Access Compliance Report

Public Rights-of-Way

(Curb Ramps)

Intersection ID: 27426	Main Street: MEADOW_RUN_LN	Cross Street: SUNINGHURST_LN	Location: NE
ADA ID: 89FF5AD5993F	Ramp Type: PerpDiag	Initial Pass/Fail: Fail	Overall Compliance: No
Severity Score: 21.25			
Codes/Mitigation Info/Possible Solution		Field Measurements/Component Compliance

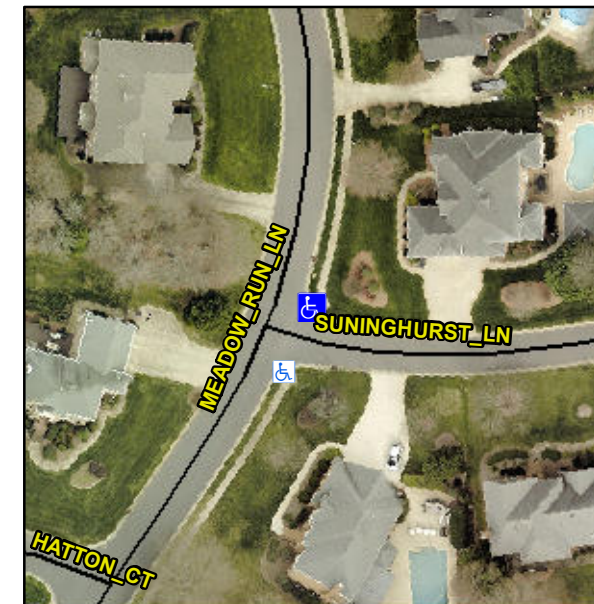
Not Found, R304.5.1, R304.2.2

Compliance	Description	Data	Compliance	Description	Data
N/A	Ramp Length (in)	94.0	No	Ramp Slope (%)	9.2
No	Ramp Width (in)	45.5	Yes	Ramp XSlope (%)	0.4
N/A	Flare Type LT	N/A	N/A	Flare Type RT	N/A
N/A	Flare Slope LT (%)	N/A	N/A	Flare Slope RT (%)	N/A
N/A	Flare Traversable LT?	N/A	N/A	Flare Traversable RT?	N/A
N/A	Landing Length (in)	N/A	N/A	DWS Provided?	N/A
N/A	Landing Width (in)	N/A	N/A	DWS Contrast?	N/A
N/A	Landing Slope (%)	N/A	N/A	DWS Length (in)	N/A
N/A	Landing X Slope (%)	N/A	N/A	DWS Full Width?	N/A
N/A	Landing Curb? (Y/N)	N/A	N/A	DWS Offset (in)	N/A
N/A	Shared Landing?	N/A			
N/A	Gutter Ponding?	N/A	N/A	Gutter Slope (%)	N/A
N/A	Gutter Lip Ht (in)	N/A	N/A	Gutter X Slope (%)	N/A
N/A	Painted X Walk1?	No	N/A	Painted X Walk2?	No
	X Walk 1 Direction	To W		X Walk 2 Direction	To SW
N/A	X Walk 1 Width (in)	N/A	N/A	X Walk 2 Width (in)	N/A
	X Walk 1 Slope (%)	0.5		X Walk 2 Slope (%)	1.4
	X Walk 1 X Slope (%)	1.4		X Walk 2 X Slope (%)	1.2

Remove & Replace Curb Ramp With Two New Directional Ramps or Equivalent.
